NMRA Recommended Practice	
Locomotive and Tender Drawbars	
Jul 17, 2025 Aug 21, 2026	RP-37 Draft

RP-37 Draft Locomotive and Tender Drawbars

Figure 1. Metal drawbar layout.

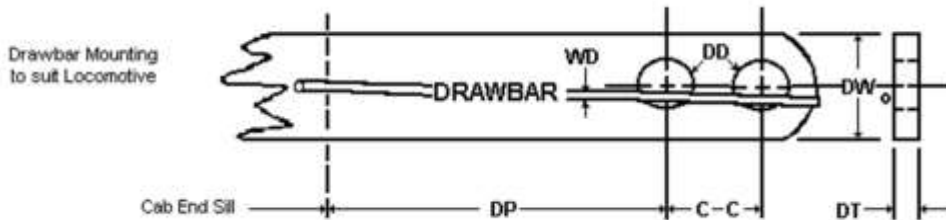
Commented [BK5]: All the drawings are cut and pasted from the 1997 RP. Once I get feedback on what needs to change, I will redraw them in Google Drawings.

Commented [BK6R5]: This was my idea but since there have been no complaints about the old drawings, I am not sure we need to spend time revising them now.

Figure 2. Metal attachment pin layout.

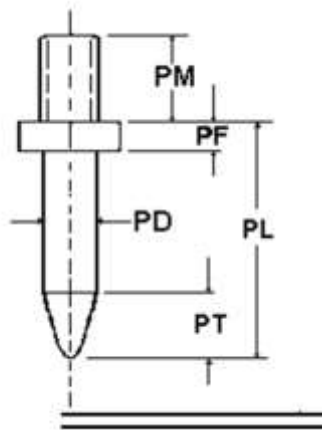
Commented [BK7]: This dimension is 3/64" (0.046875") in the 1997 RP. This seems awful short to me. It is less than the 1/16 length for TT below.

Commented [BK8R7]: I am increasing this dimension to 1/8" to provide enough height to secure the pin in the bottom plate of a tender. The new height will provide 7 threads if the bottom plate is 1/8" thick. This pin must accept the torque of the engine pulling the entire train so the additional threads seem reasonable.
